# ADDENDUM 3

**PROJECT:**  
(IFB) #R-17-002-201  
**MIDDLE STREET OFFICE RENOVATIONS**  
City of Chattanooga

**ADDENDUM NUMBER:** 3

**DATE:** 10.10.17

2 CEILING WITH EXISITING WALL DETAIL  
3" = 1'-0"

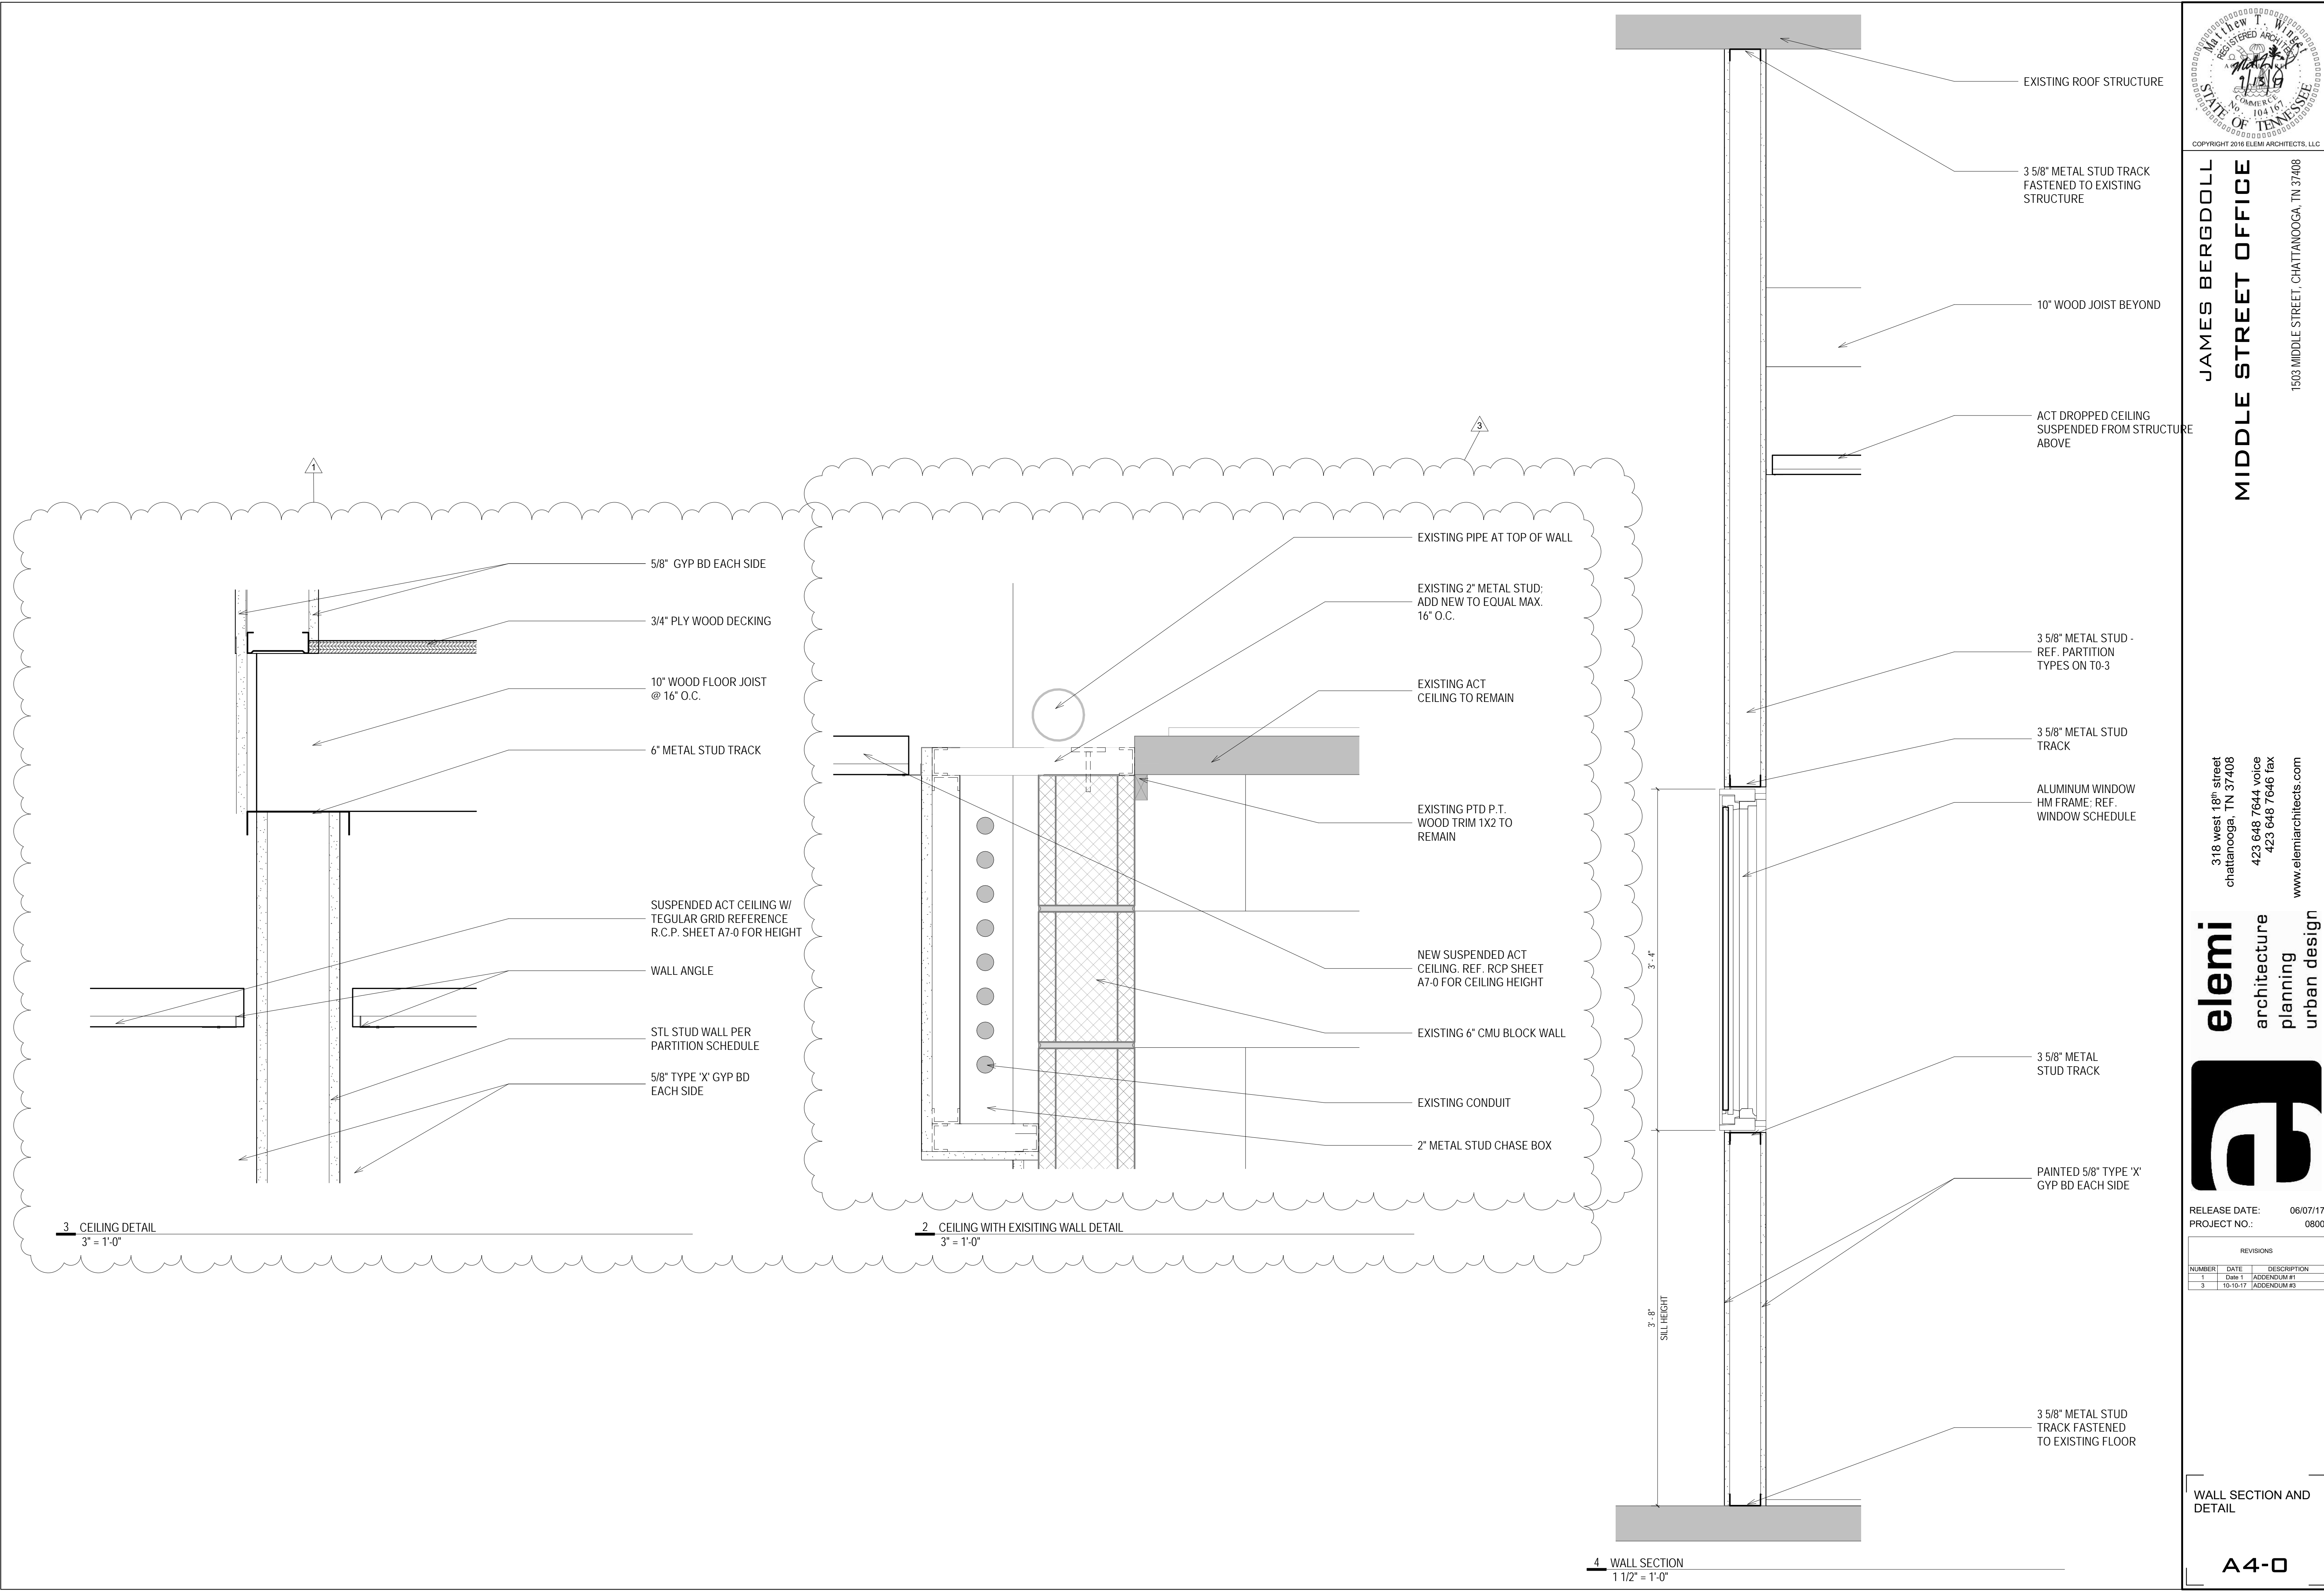
- a. ANSWER: Yes, thermostat will be relocated. Extend conduit as req'd to mount to new gyp board wall.
9. QUESTION: "Existing common wall where soffit detail 2/A4-0 was added there is not an existing 2x at top of wall and the existing piping is in the way of installing the soffit as drawn. Please advise."

Detail 2 CEILING WITH EXISTING WALL DETAIL has been modified to accurately reflect existing conditions

- a. ANSWER: Soffit should be attached as shown in 2/A4-0. It has been slightly revised for clarity.
10. QUESTION: "Reference Addendum 2 – Questions 8 and 10. There is one response saying to scrape and paint block, then answer 10 states to fur with metal and hang drywall. Please confirm that answer 8 is correct (scrape and paint) – if wall is furred and drywalled it would cause problems returning into jambs and where block meets existing drywall it would bump out. Please see photo below showing typical drywall to Masonry termination."

1 PLUMBING - DEMO  
P2-1 SCALE: 3/16" = 1'-0"

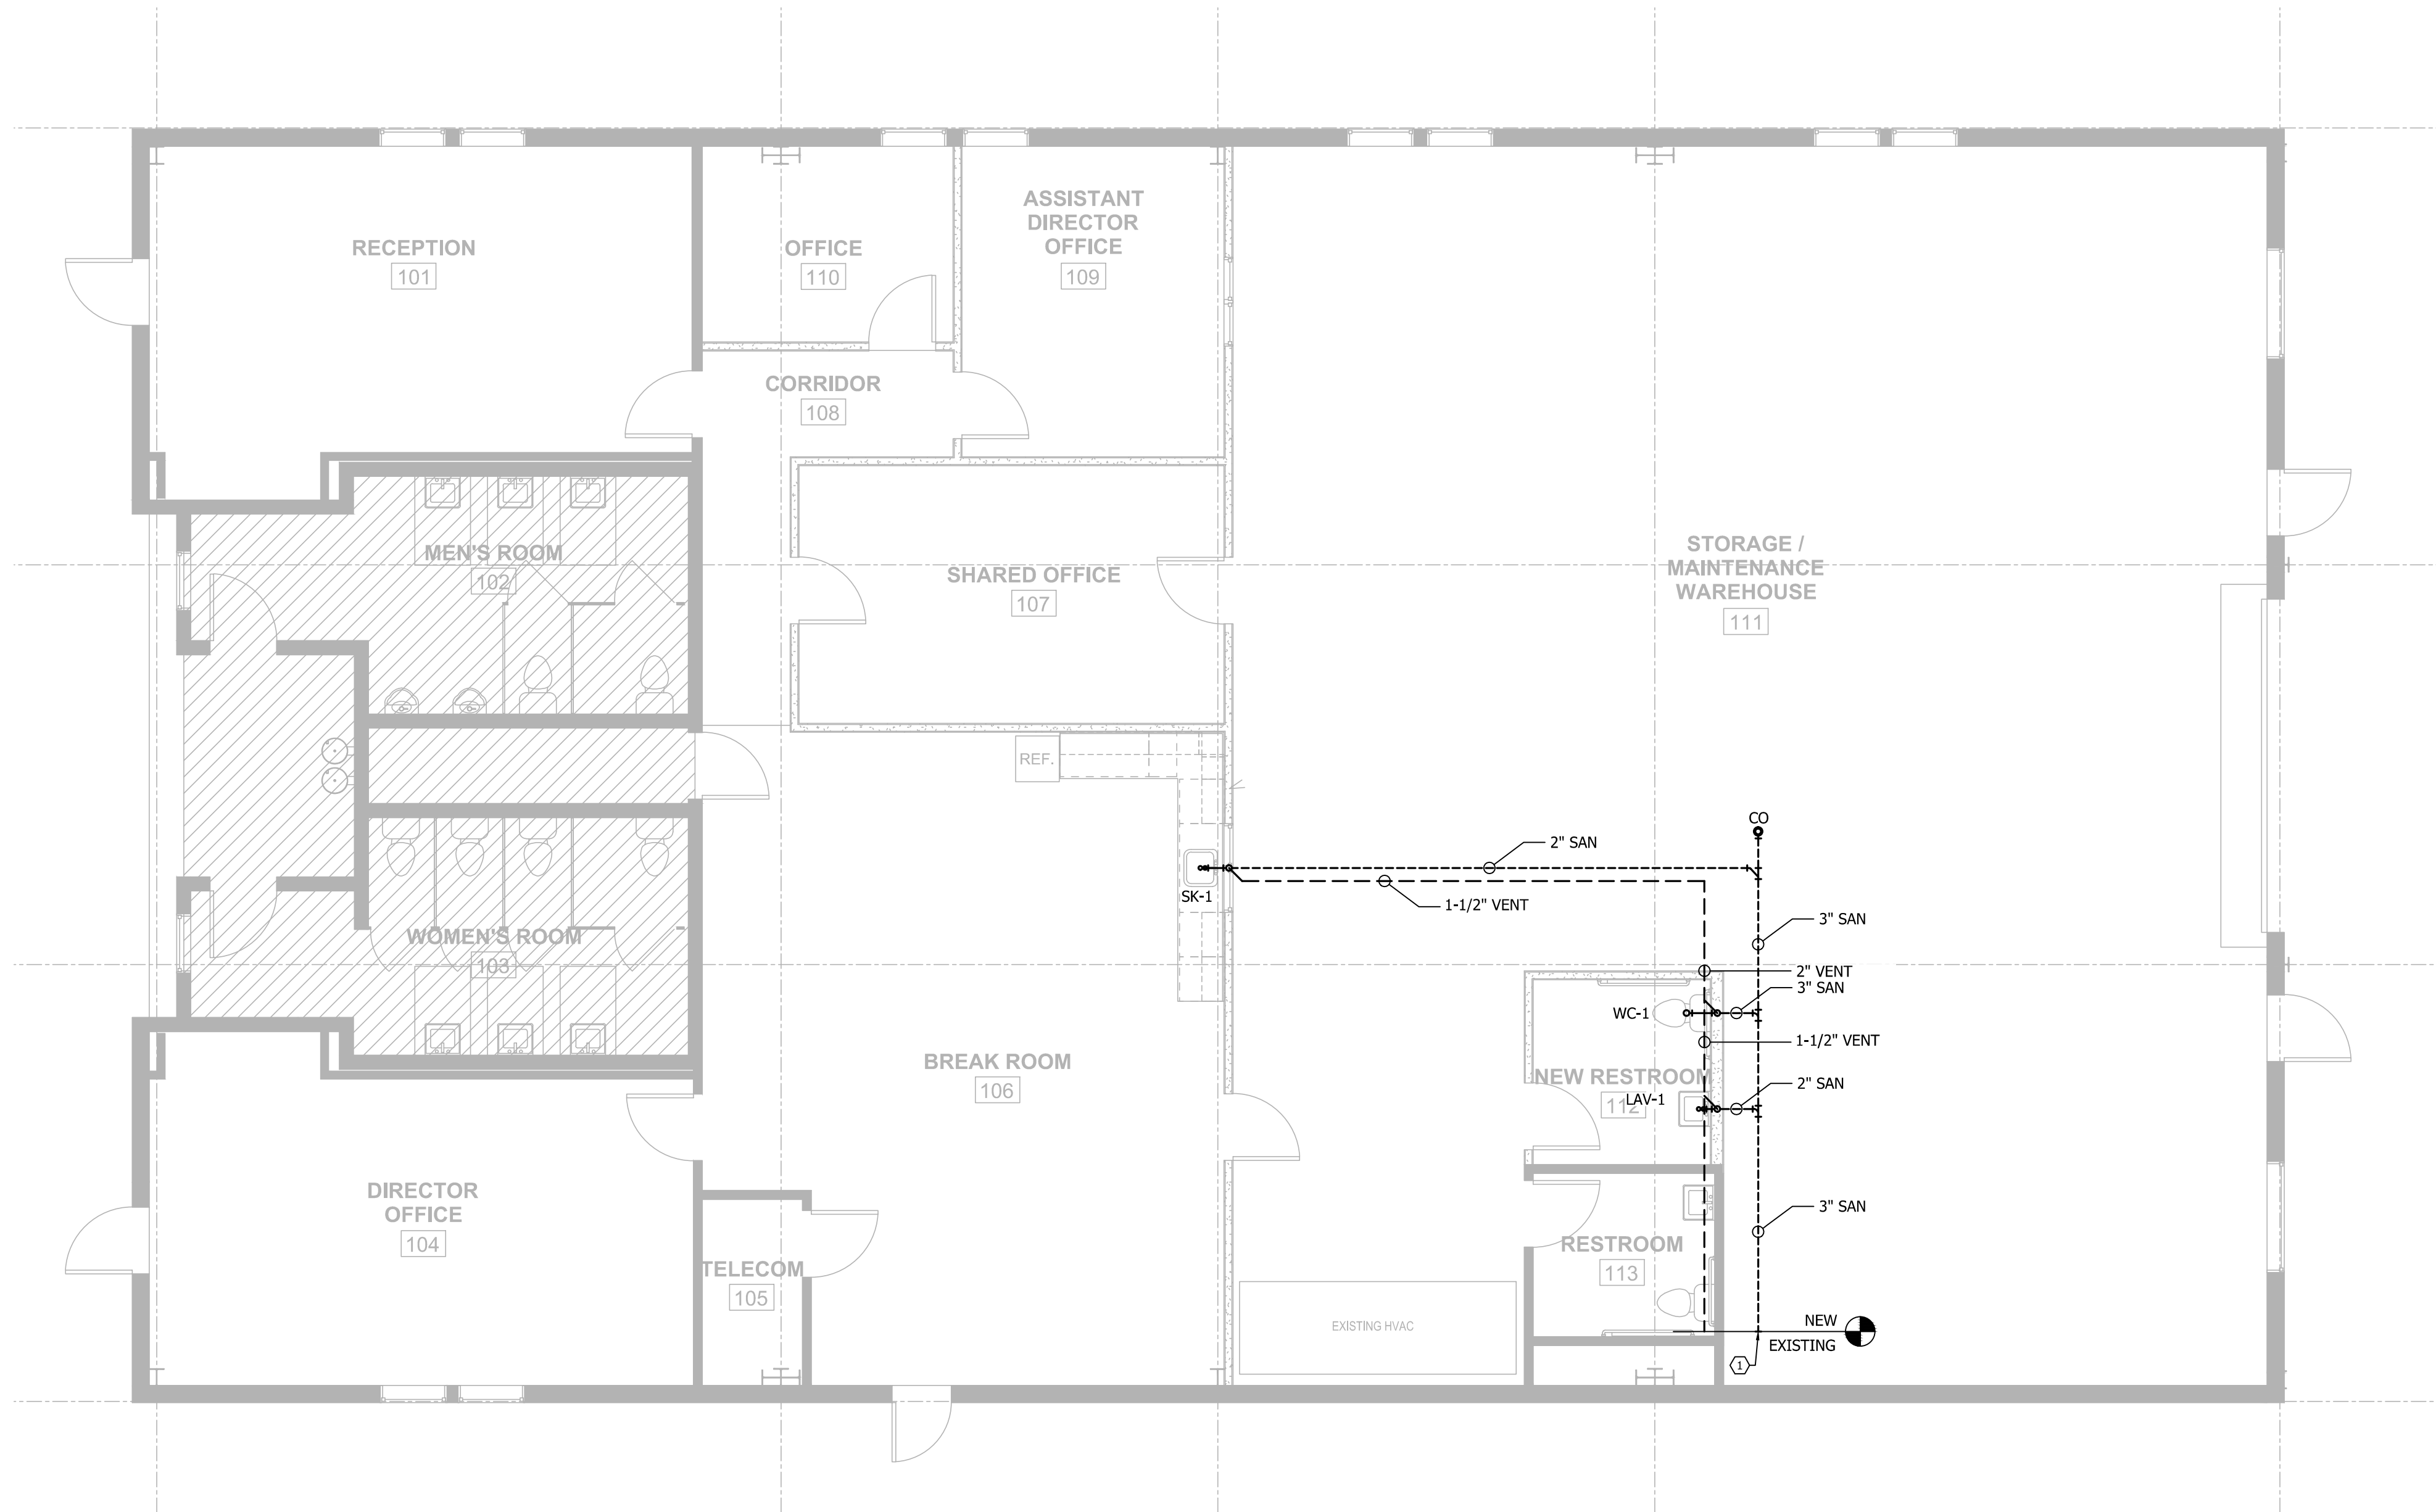
Removal of existing spigot

- 1 REMOVE AND SALVAGE EXISTING SPIGOT AND RELOCATE TO NEW LOCATION PER PLUMBING SHEET P2-2.

1 PLUMBING - DOMESTIC & GAS PLAN  
P2-2 SCALE: 3/16" = 1'-0"

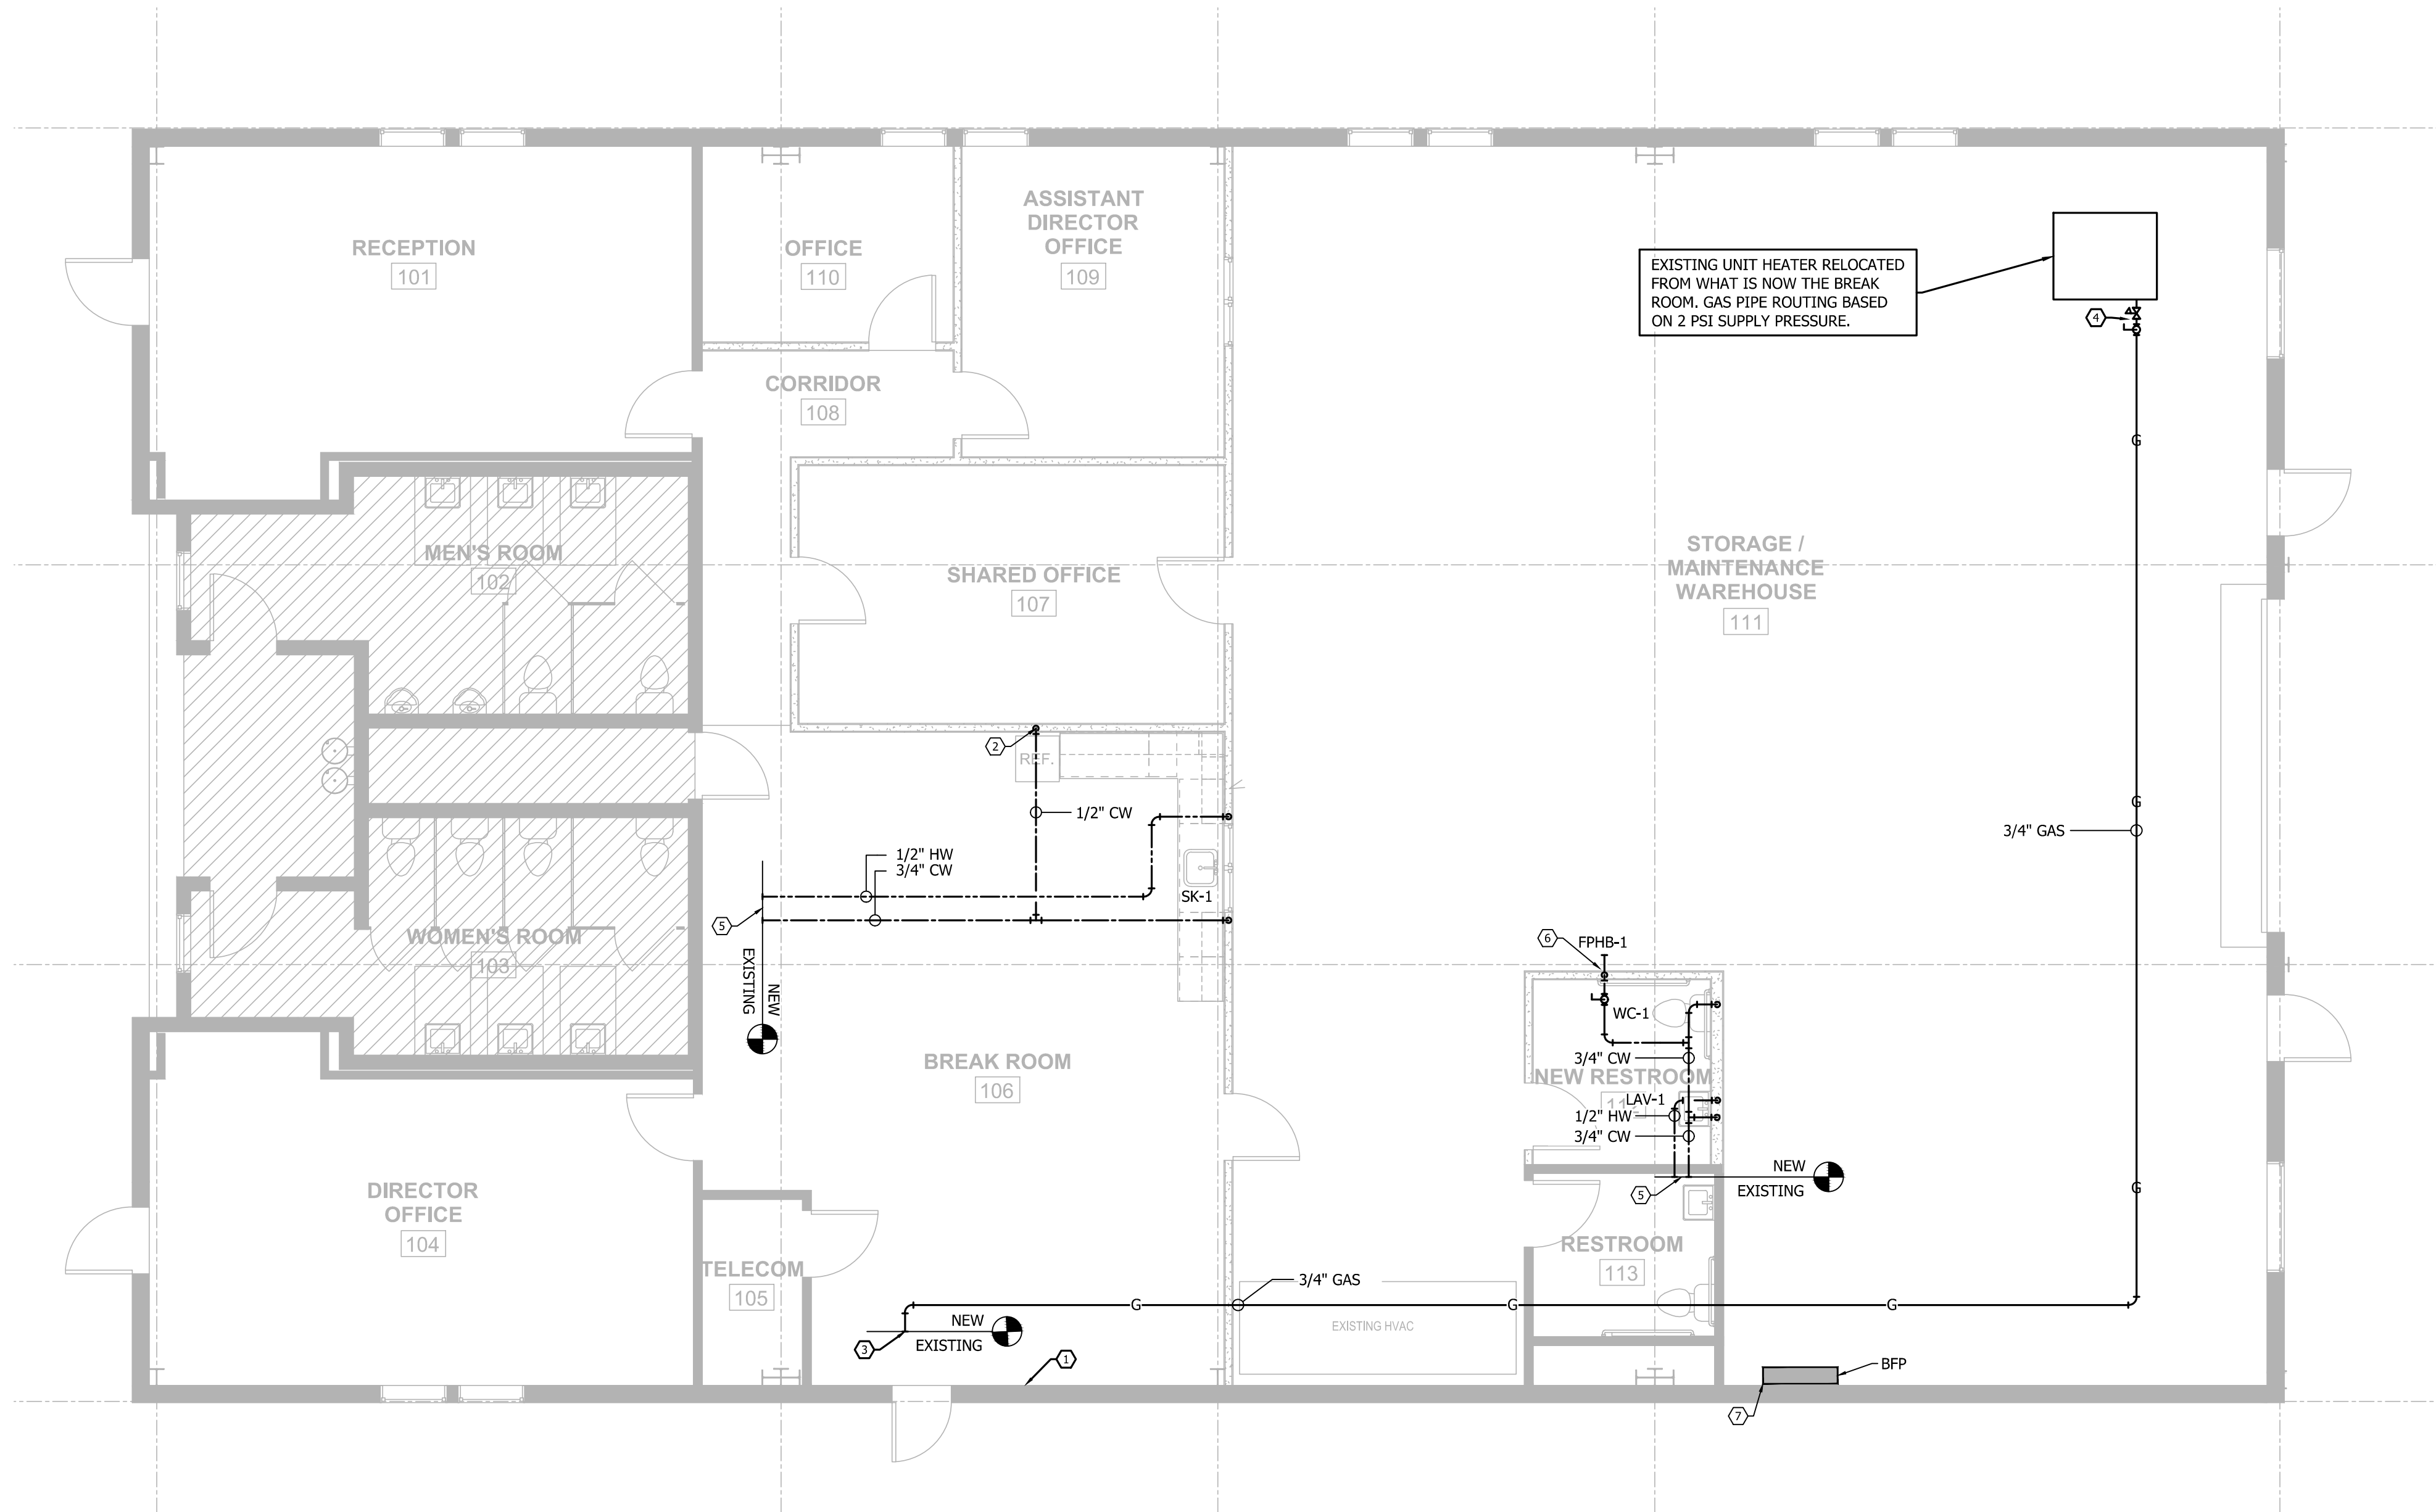
Relocation of spigot
